Model: GP605

Ref. No. : FF-T01-K1-000083-01

Location: Pick-up Tray PCB Assembly

Subject: Preventing Damage to the Pre-Last Original Sensor

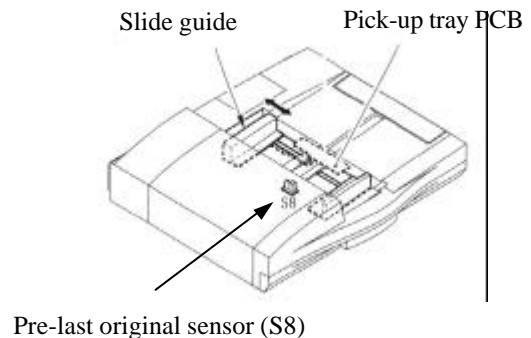
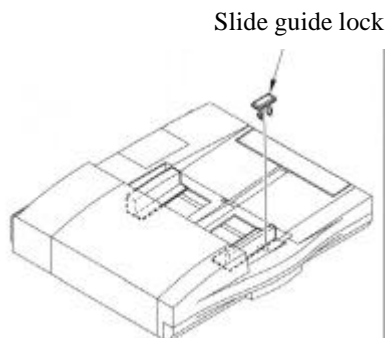
Reason: If the slide guide lock of the ADF has been removed, the contact plate (5V) operating in conjunction with the slide guide can cause a short circuit between the pattern of sensor LED (mounted on the pickup tray PCB) and the pattern of photo elements, ultimately damaging the pre-last original sensor (S8; FG6-2782-000).

If the slide guide lock has been removed, the contact plate operating in conjunction with the slide guide can cause a short circuit between the pattern of sensor LED (mounted on the pickup tray PCB) and the pattern of photo elements.

The pattern of the pickup tray PCB is changed so that the contact plate will not cause it to short circuit even in the absence of the slide guide lock.

PCB w/ measure: on the back, FG3-3025, FH13481
